Subject: Submittal of a Request for an Amendment of Certificate of Compliance (CoC) No. 9225 for the NAC-LWT Cask to Incorporate Optional Dunnage in the TPBAR Consolidation Canister for Shipments of Fewer than 300 TPBARs

Docket No. 71-9225

Revision LWT-05D

SAFETY ANALYSIS REPORT

Figure 2.10.14-4 Location of Sections of the NAC-LWT Cask Body Model

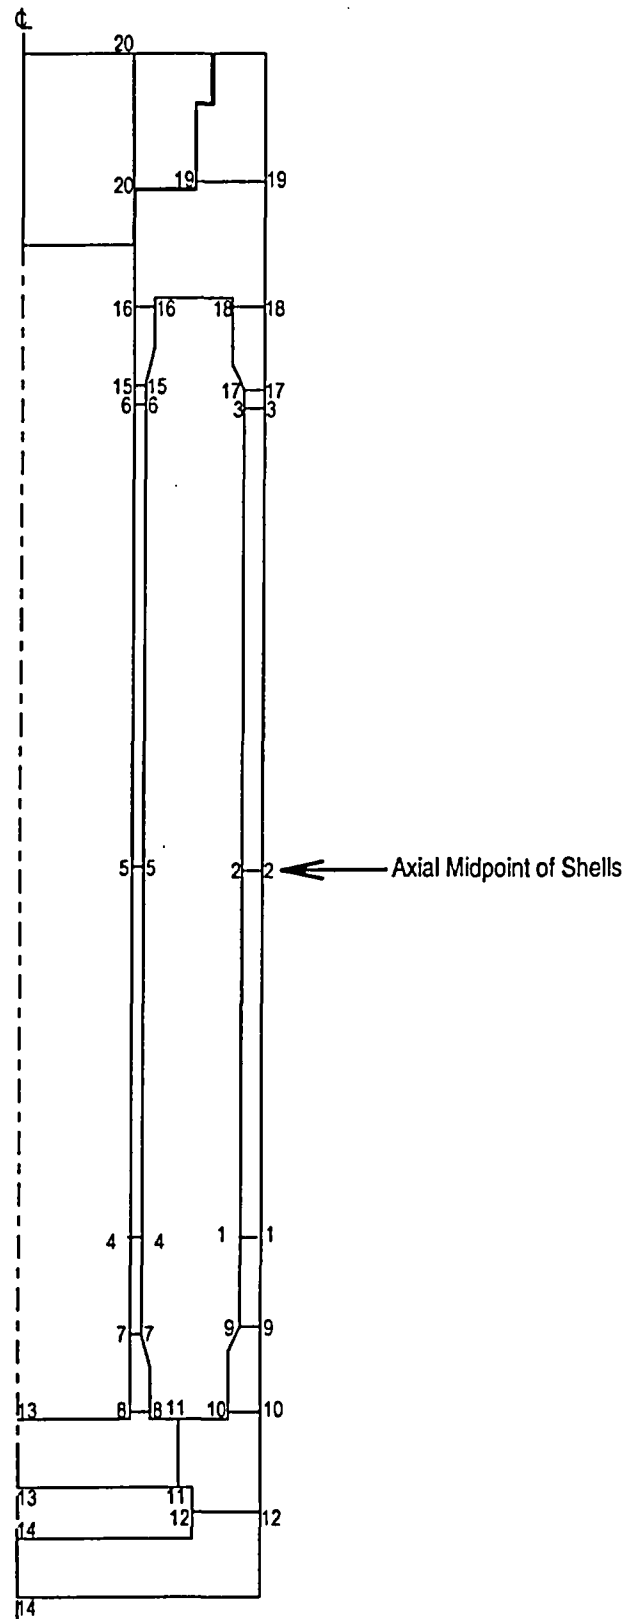
In addition, a review of Figure 2.10.14-4 in Reference 2 revealed that sections 1-1 and 4-4 were inadvertently left off the figure. The missing information has been added to the figure and the revised figure is being submitted as part of the attached LWT-05D changed SAR pages. This change only completes the information presented; it does not alter it in any way.
